IDAP REPORT

Property:	14 Amaroo Avenue STRATHFIELD Lot: 63 DP: 35995 DA2021.294
Proposal:	Demolition of existing structures, construction of a two (2) storey dwelling house with basement level, front fence, attached shed and ancillary landscaping.
Applicant:	T Taouk
Owner:	R Magale
Date of lodgement:	12 November 2021
Notification period:	19 November 2021 to 3 December 2021
Submissions received:	1
Assessment officer:	G I Choice
Estimated cost of works:	\$1,738,344.00
Zoning:	R2-Low Density Residential - SLEP 2012
Heritage:	No
Flood affected:	No
Is a Clause 4.6 Variation Proposed:	No
RECOMMENDATION OF OFFICER:	APPROVAL

Figure 3: Proposed ground floor plan

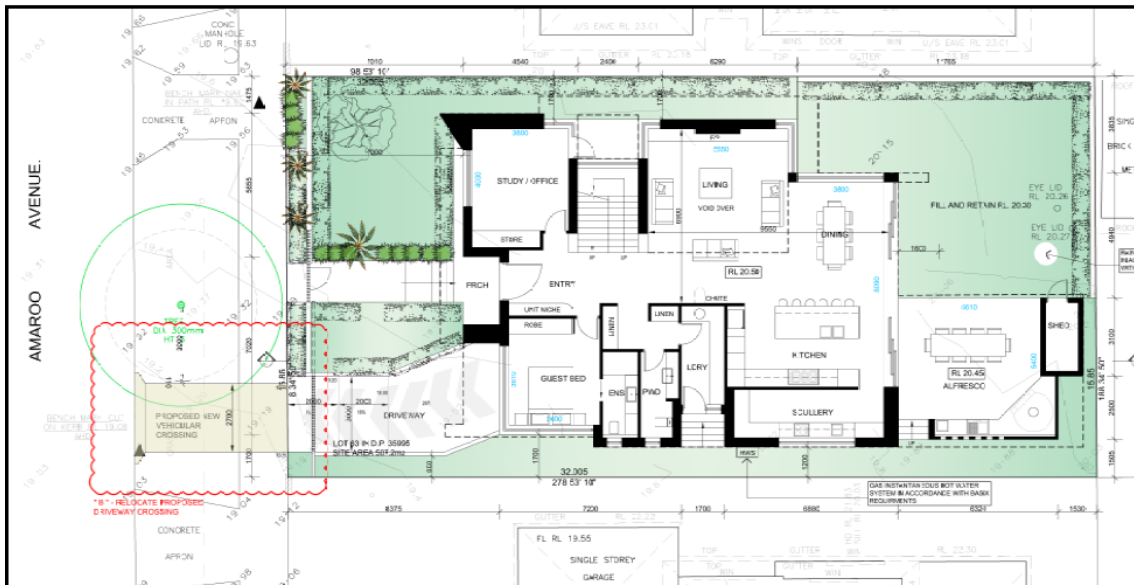
The basement plan was to be amended so that the entire basement area is limited to and contained within the footprint of the dwelling at ground level.

The proposal involves significant excavation works for the provision of a basement, driveway ramps and ancillary works. The extent of excavation for the basement (as amended) has been limited to the footprint of the ground floor above and access to and from the basement. The depth of excavation has been kept to minimum requirements to comply with Council's DCP controls and all ancillary works have been limited to what is required to provide access to and from the basement. The proposed works are unlikely to disrupt or effect existing drainage patterns or soil stability in the locality or effect the future use or development of the land. It is unlikely to effect the existing and likely amenity of adjoining properties and there is no potential for adverse impacts on any waterways, drinking water catchment or environmentally sensitive areas. The proposed excavation works are considered to satisfactorily address the objectives of this clause.
